Report to the Future Melbourne (Planning) Committee

Planning Scheme Amendment C190 Arden-Macaulay

2 August 2016

Panel Report pursuant to Section 25 of the Act
Melbourne Planning Scheme Amendment C190
Arden–Macaulay Structure Plan Implementation

Figure 6: The MSS review Panel recommendation

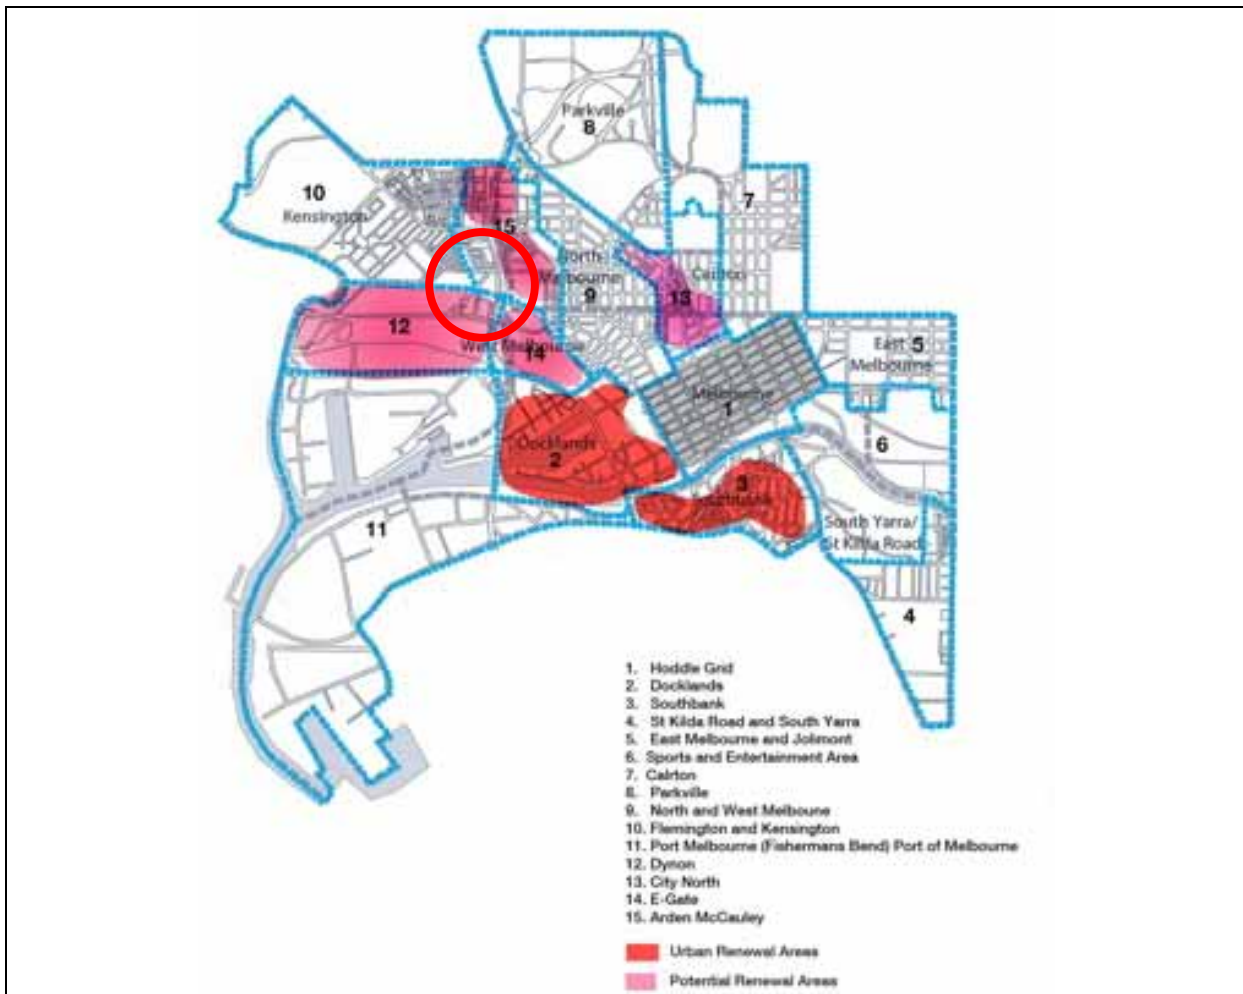
As part of its report the panel for Amendment C162 recommended significant changes to the growth framework plan; these are shown in Figure 6. Specifically it recommended that the renewal designation be deleted from the area.

Figure 7: The current MSS (extract)

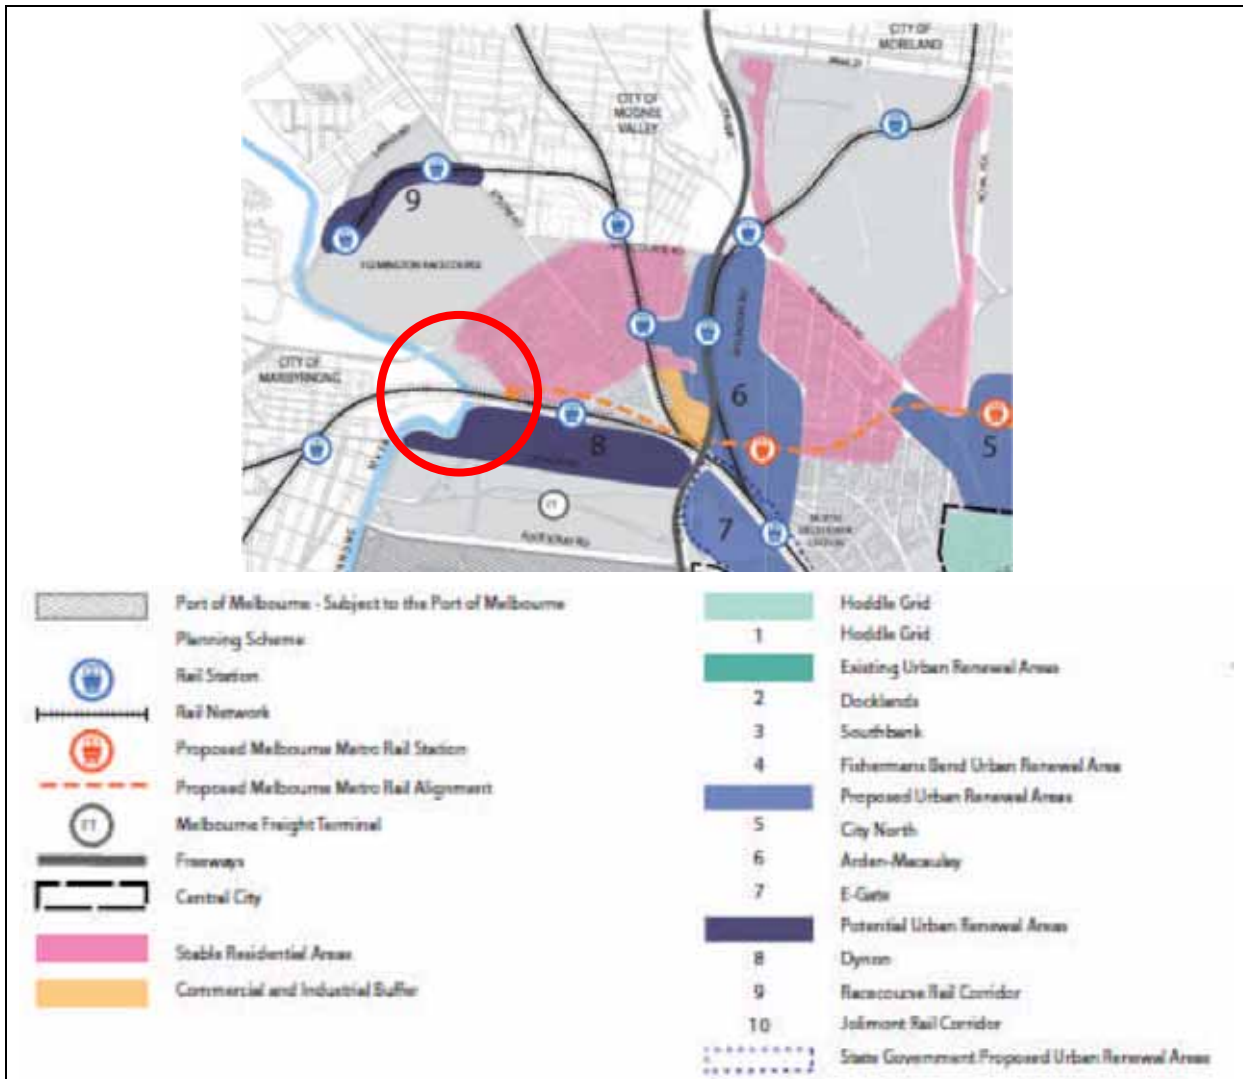
In response to the Amendment C162 panel recommendations Council substantially improved the growth framework plan. This progressed the Amendment C162 panel recommendation in a number of ways:

- refining boundaries of the urban renewal area
- distinguishing between ‘proposed’ and ‘potential’ urban renewal areas
- specific changes in relation to the area around Allied Mills were:
 - part of the area shown as proposed urban renewal
 - part of the area shown as a commercial and industrial buffer.

MAP OF THE PANEL'S RECOMMENDED DDO AREAS

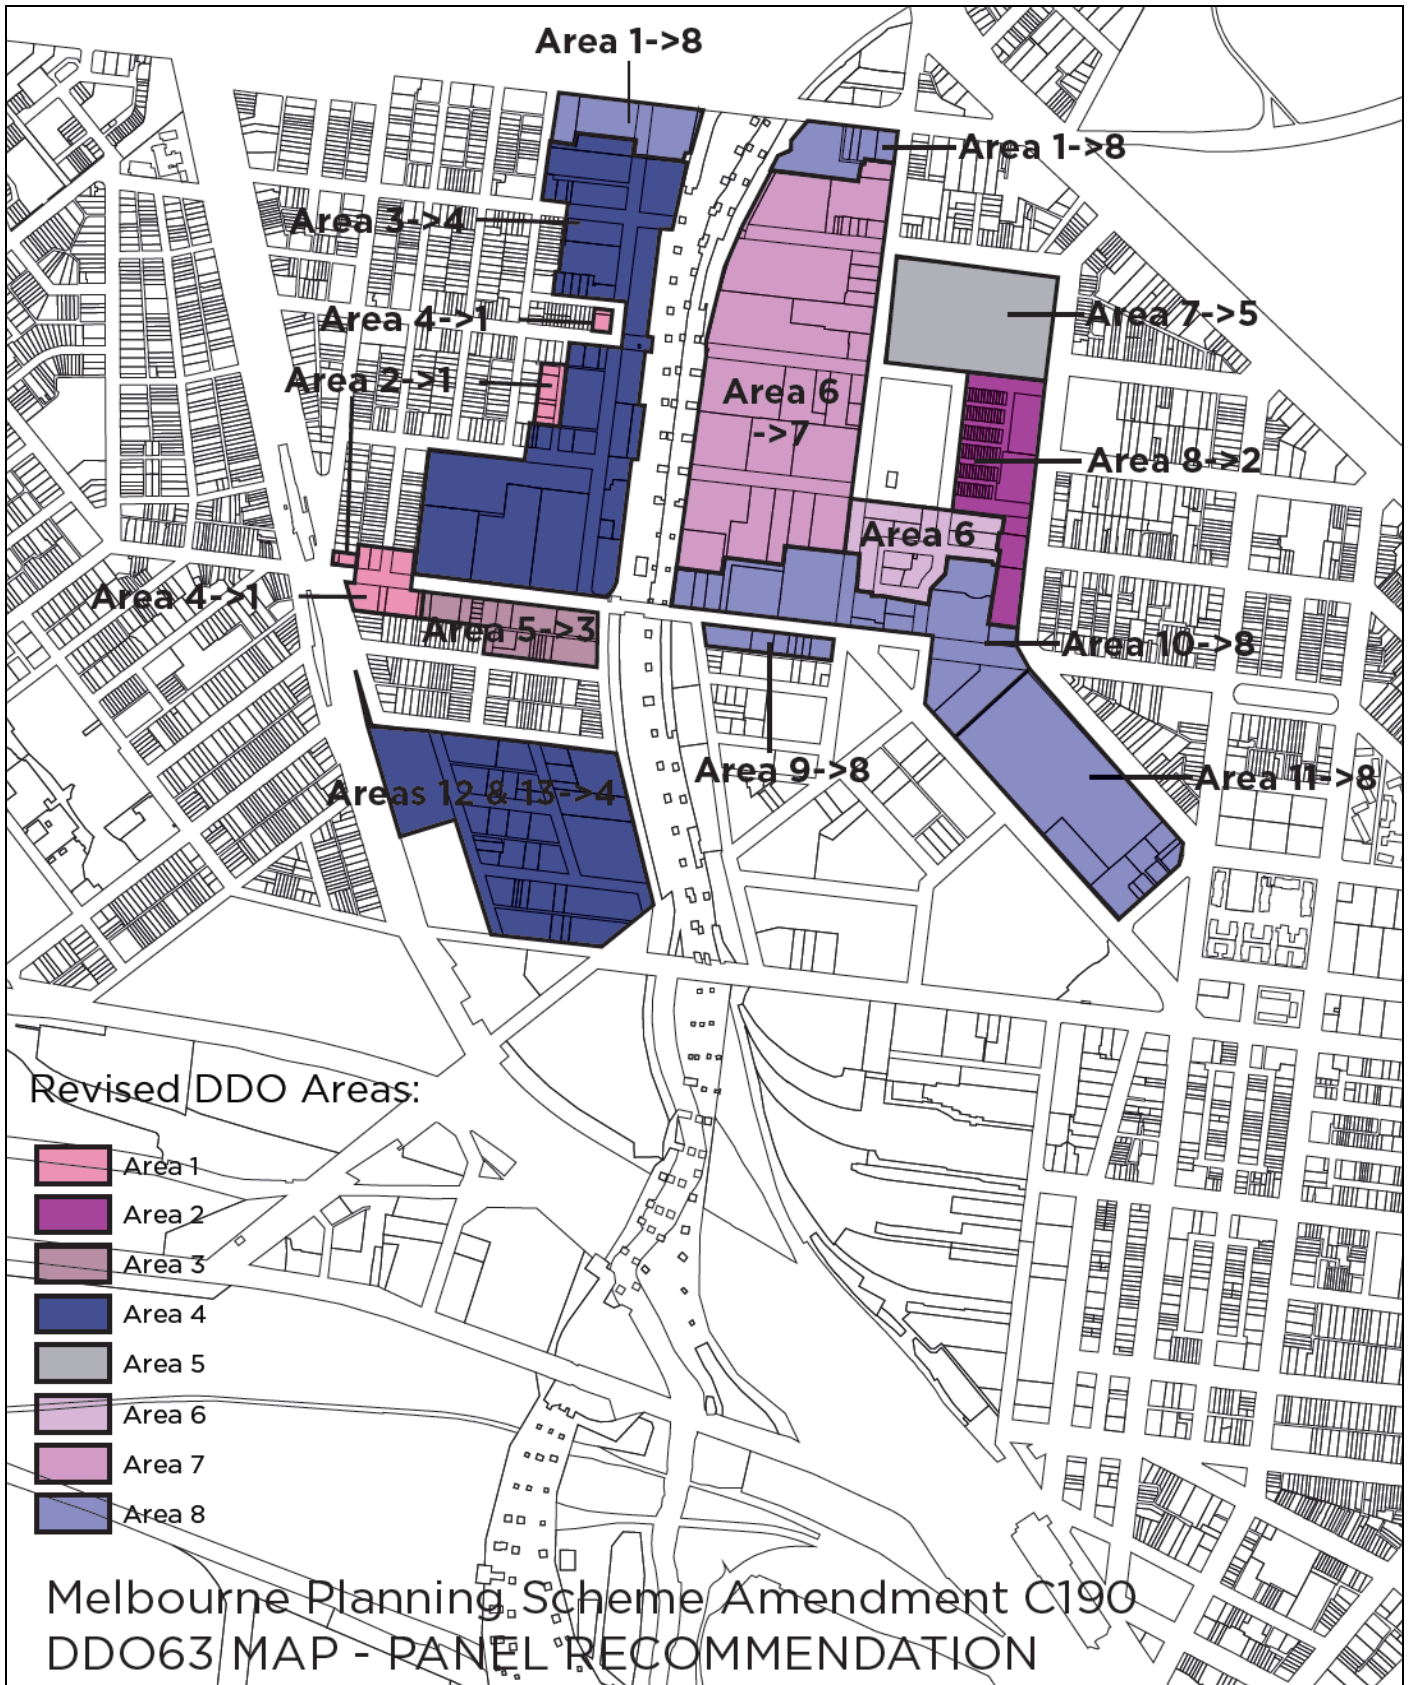
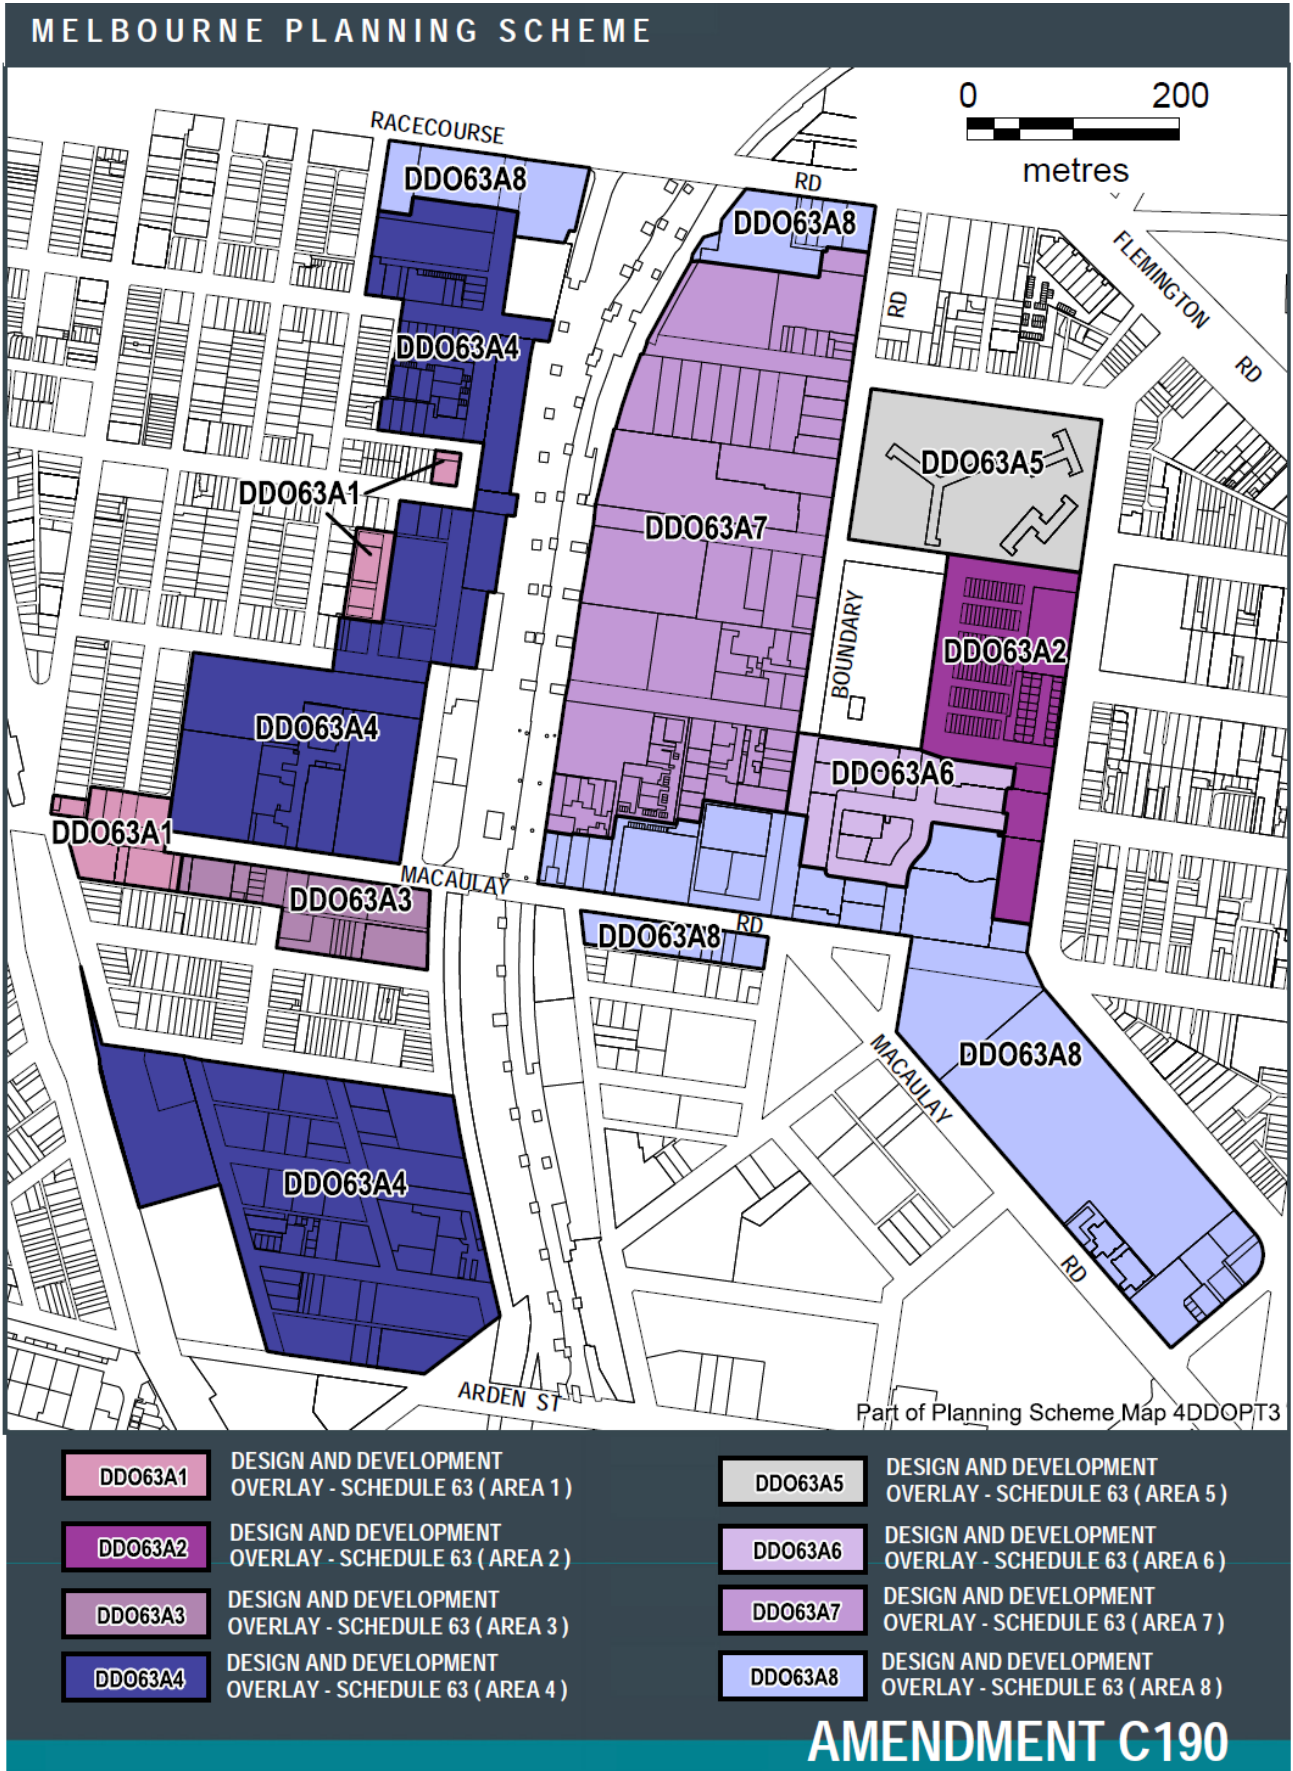
VicTrack Land	Commence negotiations with VicTrack for the purchase of their land	Partially Agree	The City of Melbourne and the State Government are investigating various options.
Environmental Audit Overlay (EAO)	Undertake a precinct wide review of contamination issues with the view to refining the application of the Environmental Audit Overlay	Disagree	<p>The Panel considers that it is appropriate to apply the Environmental Audit Overlay to land being rezoned to Mixed Use.</p> <p>However, it also notes that the Environmental Audit Overlay is a very blunt planning tool and there will be broad benefits in undertaking a precinct wide analysis, not least for identifying land unsuitable for open space.</p> <p>The EAO is the only planning tool available to ensure potential contamination is investigated and remedied by the applicant. It is considered to be appropriate for developers, rather than Council, to undertake this work if and when they wish to redevelop the land.</p>

MANAGEMENT'S RECOMMENDED DDO AREAS
